**SAN ANTONIO WATER SYSTEM**  
**Interdepartment Correspondence Sheet**

**Subject:** Zoning Case Z2023-10700133 (Evans & Encino Commons Commercial  
Development)

**Date:** July 14, 2023

IO COMMONS COMM. DEV. (FIGURE 1)

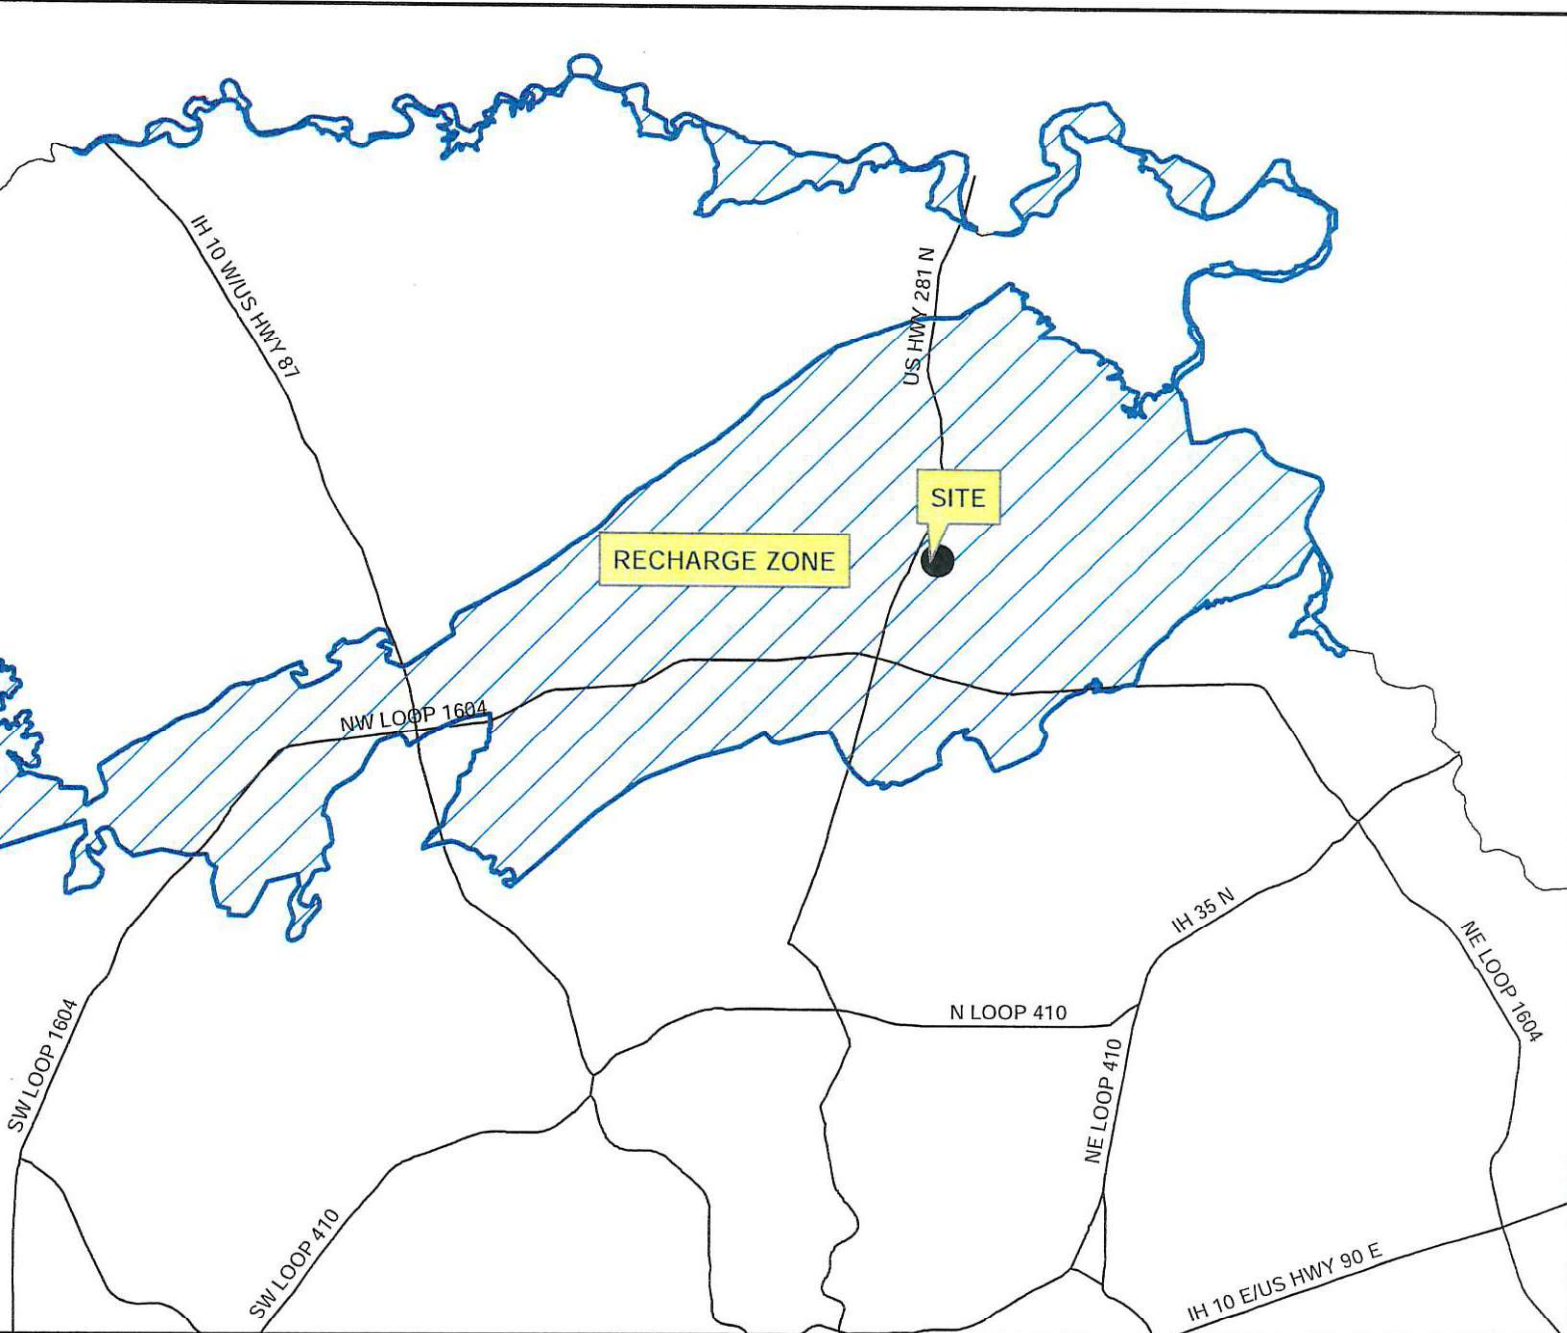
The subject property is within City Council District 9, approximately 830 feet east of Evans Rd. and US Hwy. 281 North intersection. The property lies within the Edwards Aquifer Recharge Zone (Figures 1 and 2).
